Ref: C0009-WBH-XX-XX-LT-1004

RE: Hinckley & Bosworth Planning Application 23/01023/HYB and Rugby Borough Council Planning Application R23/1047 – Cond 21

Hinckley & Bosworth – Planning Condition #21

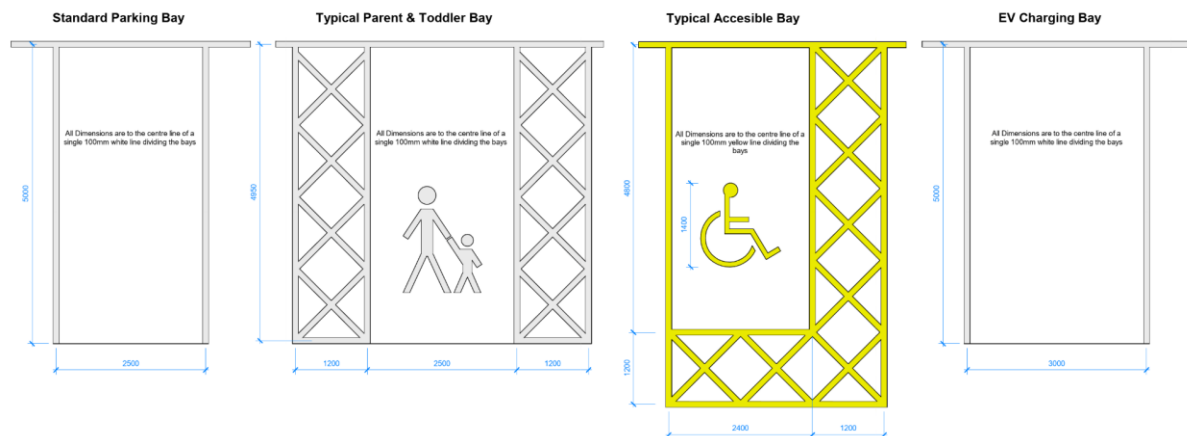
Query: *Hard surfacing – detail what hard surfacing will be on the access road likely to be existing or improved tarmac to existing but it’s not clarified on the plan just blank but is included in the red edge of the site so needs to be clarified;*

Response: Hatch added to drawing to identify existing highway. This area is subject to a Section 278 Highway Approval which is currently in development.
